Re: Indian Point Unit No. 2
Docket No. 50-247

SUBJECT: Reply to Request for Additional Information
Passive Autocatalytic Recombiners

**RESPONSE
TO
REQUEST FOR ADDITIONAL INFORMATION**

Figure 2-1 -- Evaluation of PAR Chemical Environment

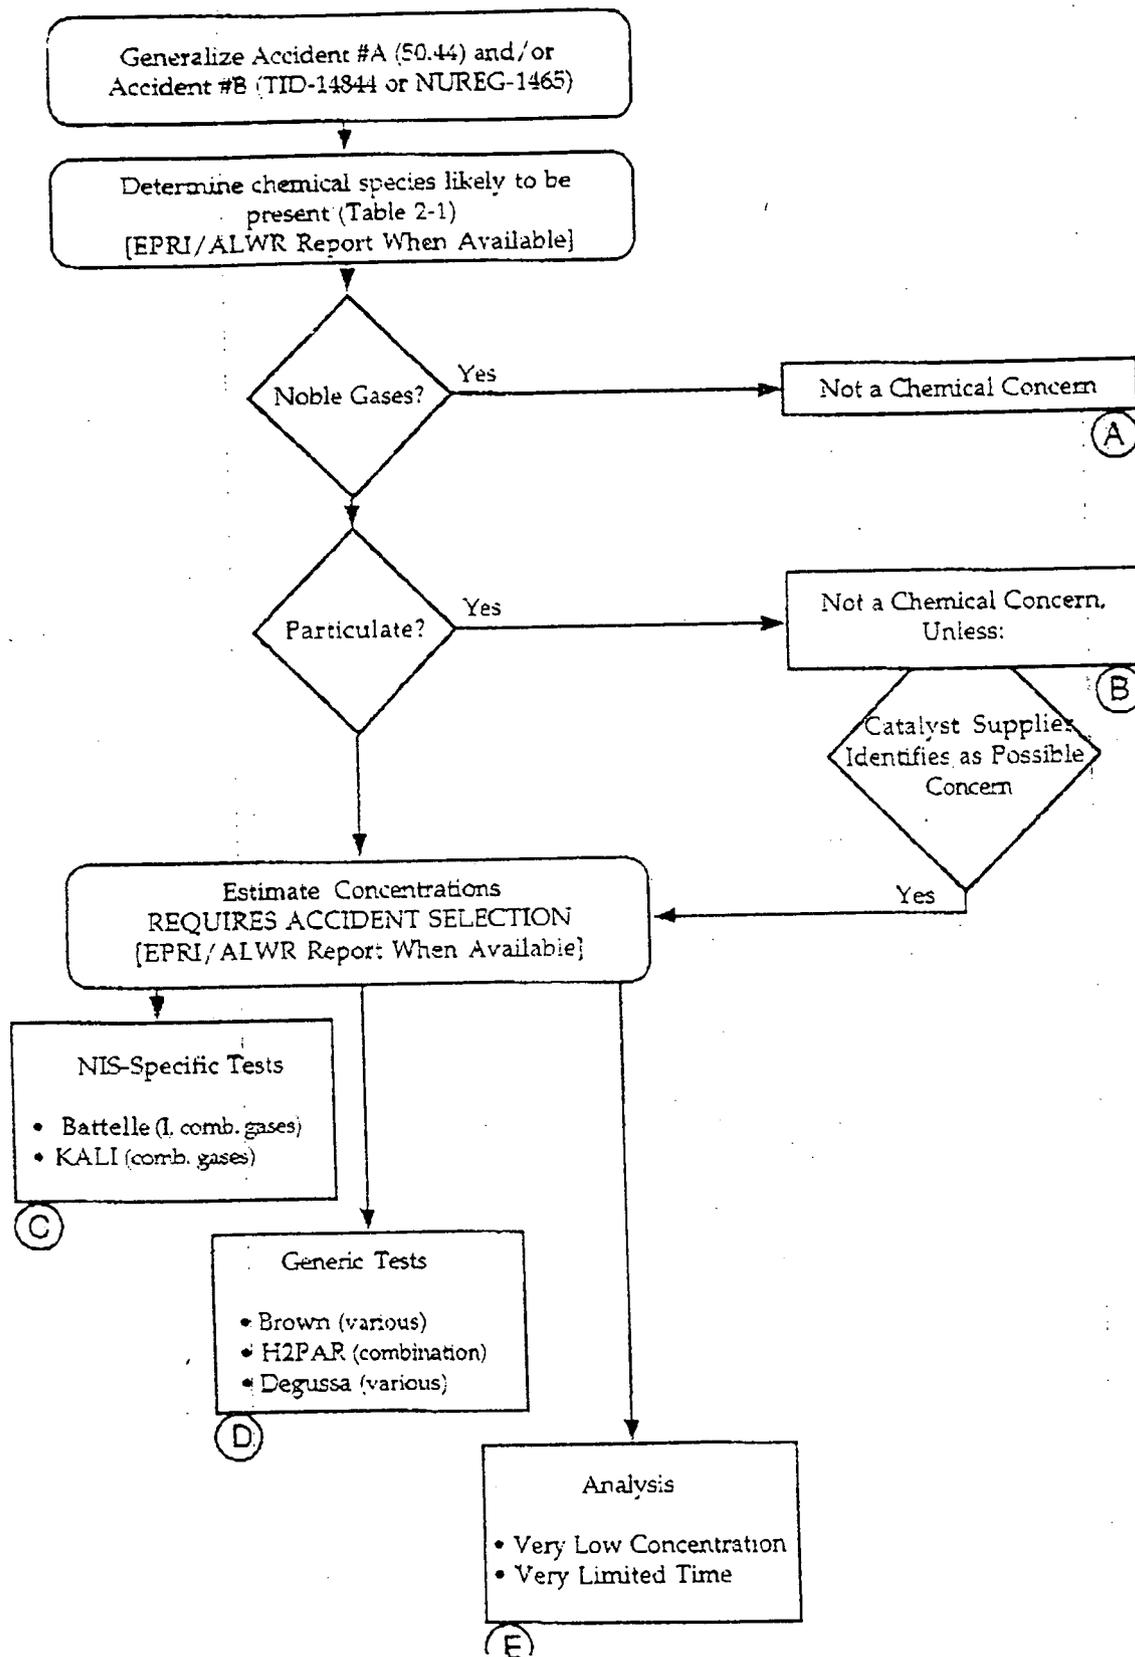
- 2) How are you going to determine the effect the following fission products would have on the ability of the palladium catalyst to recombine hydrogen and oxygen: (1) xenon, (2) krypton, (3) bromine, (4) methyl iodine, (5) cesium, (6) rubidium, (7) tellurium, (8) antimony, and (9) selenium?

Attached figure 2-1 represents the logic used by PAR developers.

From this list of potentially present chemicals, noble gases were immediately removed as possible inhibitors because such gases are not generally reactive and certainly not with noble metal catalysts. (Disposition "A" on Figure 2-1).

Next, particulate forms of potentially present chemicals were removed from consideration as chemical inhibitors because their physical form prevented them from significant chemical interaction with the noble metal catalyst sites. (See the response to questions 13 and 14 for discussion of "physical" inhibition by particulates and debris.) For added assurance, the supplier of the particular catalyst was asked to verify that they had no evidence of chemical poisoning by particulate forms of such chemicals, for example by revaporization at elevated temperatures. (Disposition "B" on Figure 2-1)

- * Testing of the inhibition chemical at expected concentrations with the specific catalyst used. (Disposition "C" on Figure 2-1.)
- * Review of test data from testing on comparable catalysts. (Disposition "D" on Figure 2-1.)
- * Analysis that significant chemical damage to the catalyst would not occur, generally due to low concentrations present or limited time for the presence of chemicals or both. (Disposition "E" on Figure 2-1.)

For the development of the NIS Ingenieugesellschaft mbH (NIS) PAR only gaseous forms of iodine and mixtures of combustion gases were specifically tested (Disposition "C".) Nevertheless, Figure 2-1 indicates other possible dispositions for other chemicals. As described below, EPRI work (ref. 5) largely validates the overall list of potentially present inhibitors and should describe which additional chemicals can be assigned to Disposition "C" or "D".

FIGURE 4-1

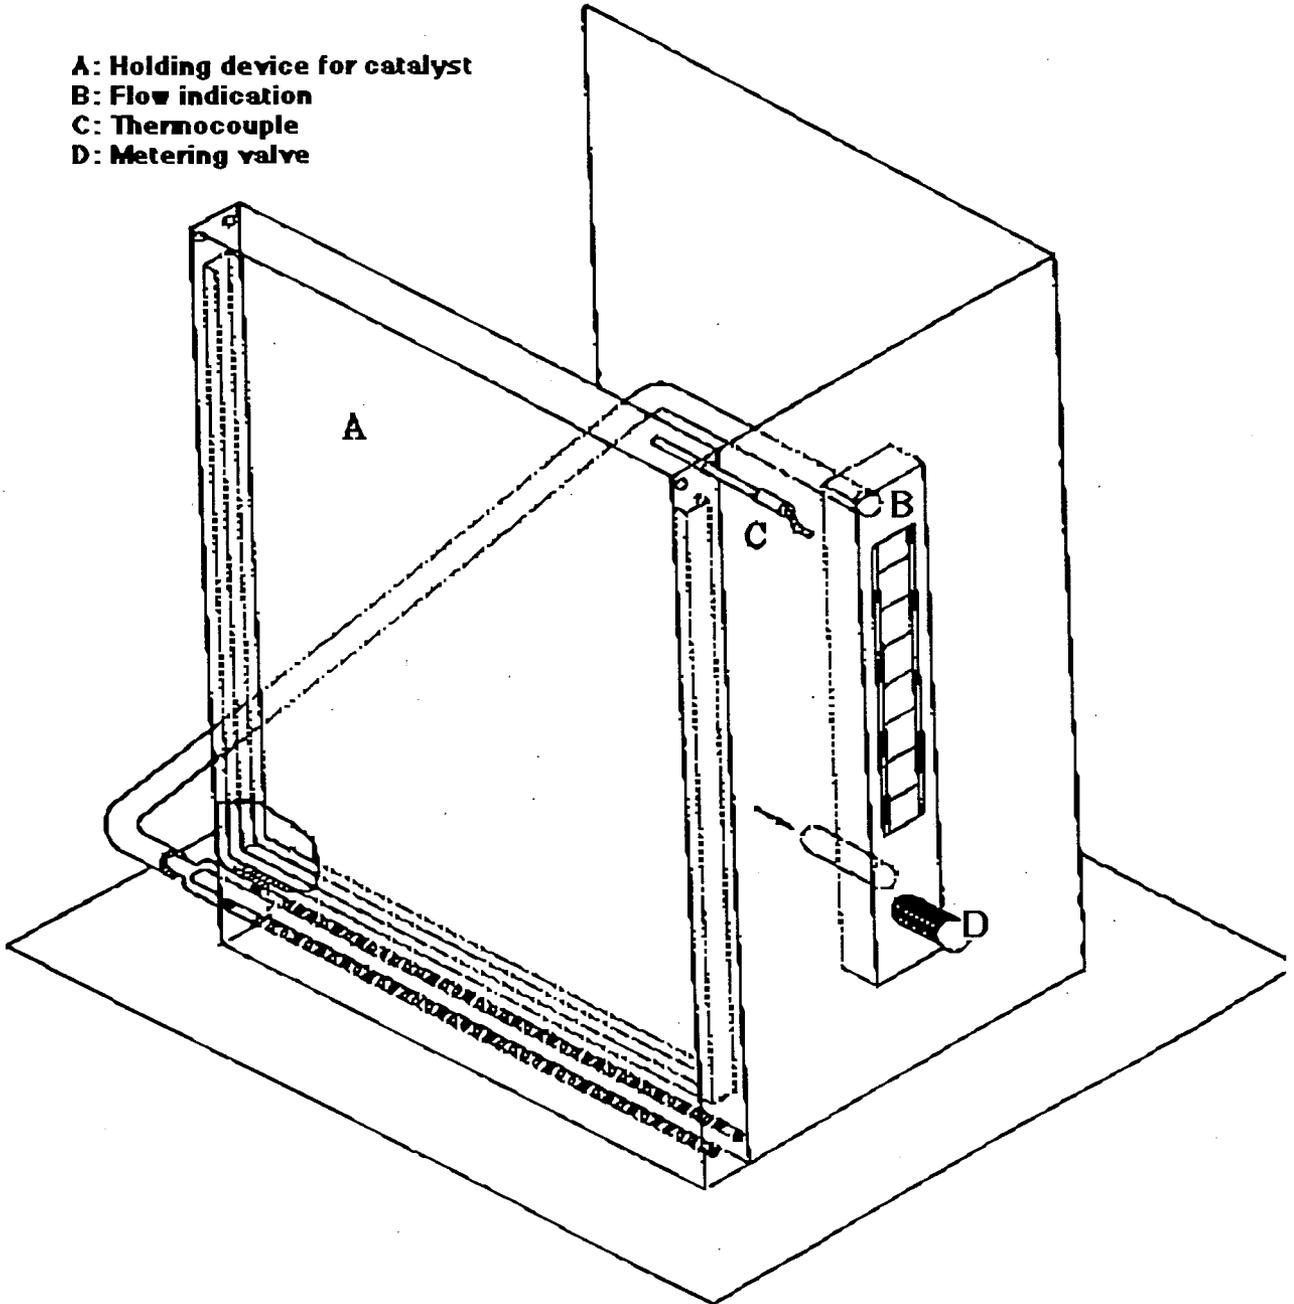
- 4) The submittal states that periodic surveillance will confirm that unexpected degradation does not go undetected. Provide a description of the proposed surveillance and the basis for the corresponding exit temperature for a particular hydrogen mixture test gas. What additional surveillances will be done if the sample plate tested should fail? This should be incorporated into the revised safety analysis report

Periodic surveillance will consist of visual examination plus testing of individual plates for indication of significant change in response to a known hydrogen gas mixture. This technique was developed by NIS and was also used by Wyle Laboratories in testing the effects of radiation on a single plate (ref-1).

The individual plate is inserted into the test chamber (see figure 4-1) and a known flow of 1%-hydrogen-in-air is injected into the chamber. The plate outlet temperature is measured and compared with measurements on new plates. The plate will be judged to be undegraded if the temperature developed is within the acceptable criteria. The acceptance criteria is being developed in baseline testing for the NIS test equipment.

FIGURE 12-1

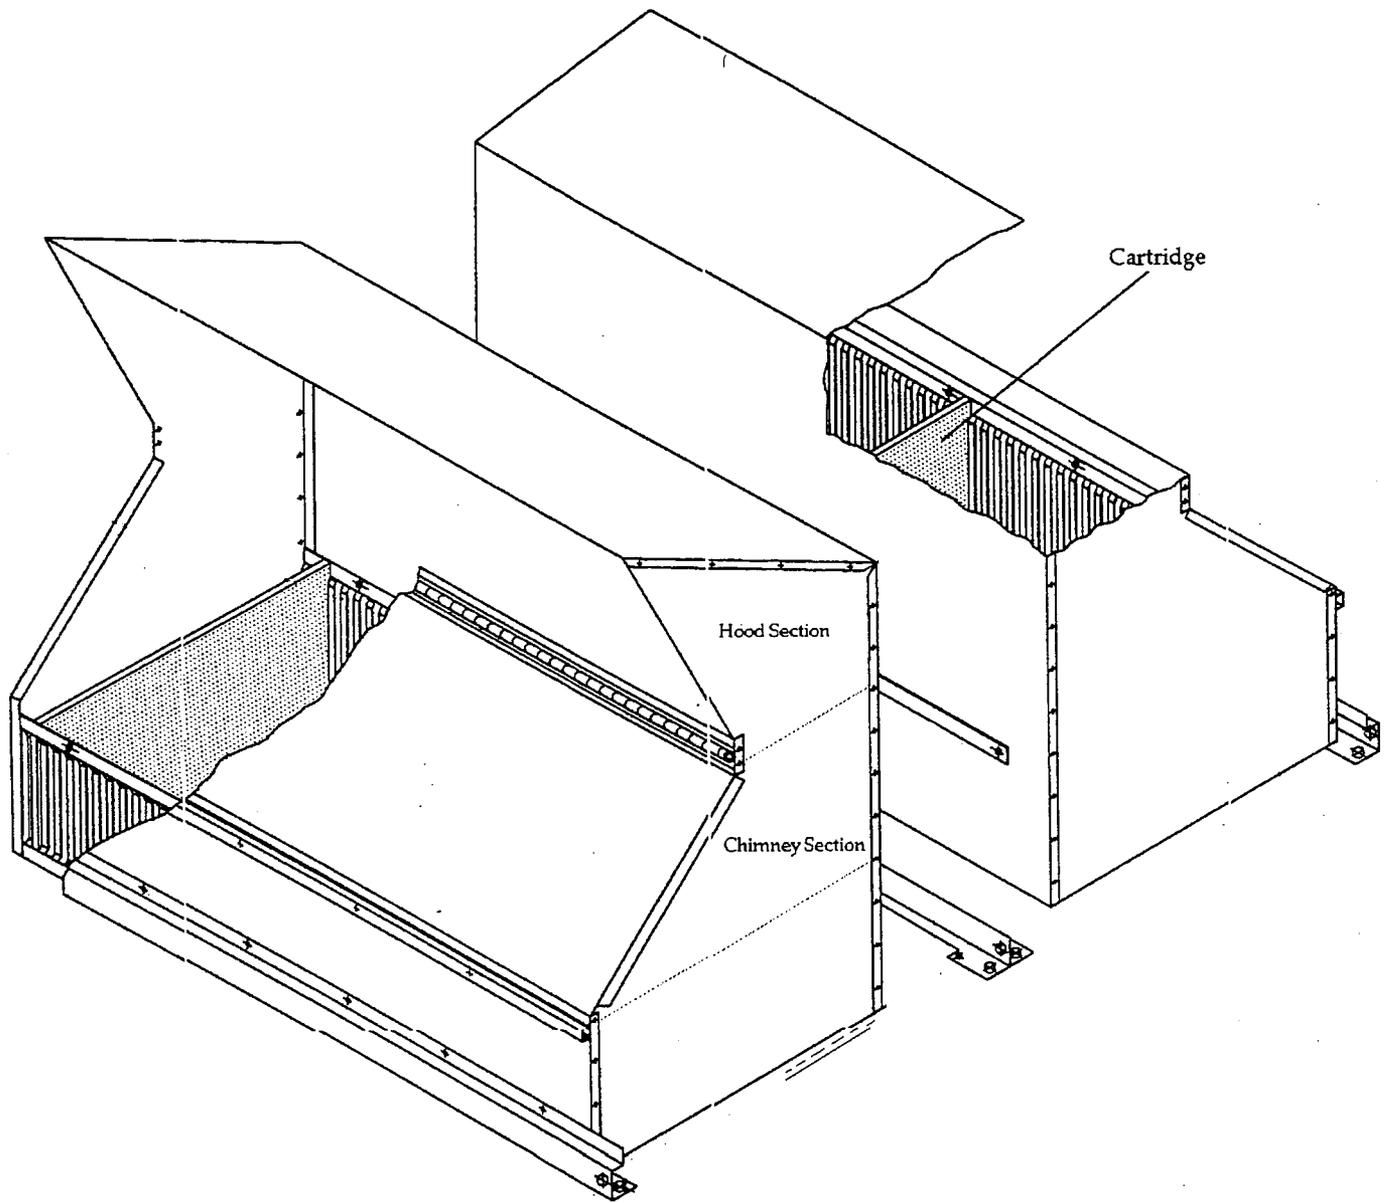
- 12) What affect will the containment spray hood have on PAR performance? What affect would chemical additives in the containment spray have on PAR performance?

The PAR configuration that is being installed at IP2 is shown in figure 12-1.

The spray hood is expected to have a neutral to positive effect on PAR gas flow rate compared with test configurations used for validation noted in question #8. Such testing was done without the spray hood. Calculations done by NIS have indicated a very minor theoretical decrease in flow due to the turning-portion of the hood but that decrease is significantly less than the increase of flow due to the height of the spray hood itself.

Wyle will be conducting tests using plant specific chemical spray which are expected to indicate that the spray chemical additives do not have a significant impact on the reaction of a PAR section with hydrogen. NIS is conducting similar "single cartridge" testing.
